#### **COUNCIL SUBMISSION**

NOTICE OF EXHIBITION OF ENIVIRONMENTAL IMPACT STATEMENT FOR THE UPGRADES TO CARLINGFORD WEST PUBLIC SCHOOL AND CUMBERLAND HIGH SCHOOL (59-73 FELTON RD AND 183 PENNANT HILLS RD, CARLINGFORD)

Figure 1 - Preferred alignment of the preferred public access easement

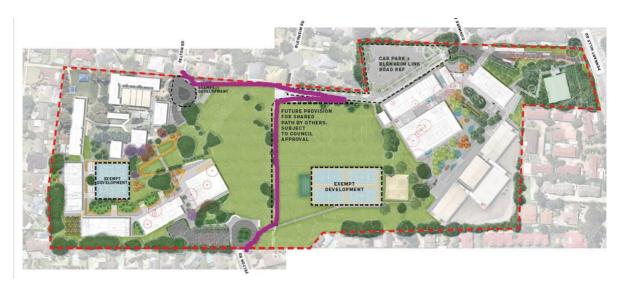
- The path along the eastern boundary connecting Blenheim to Felton East should be 3.0m wide to allow for shared use
- A 5m public access easement in Council's benefit is to be explored along the purple line at the below image. This should be conditioned within 5 years of OC at no cost to Council. This will increase connectivity and permeability between Blenheim St and Felton Rd West and East outside of school hours.
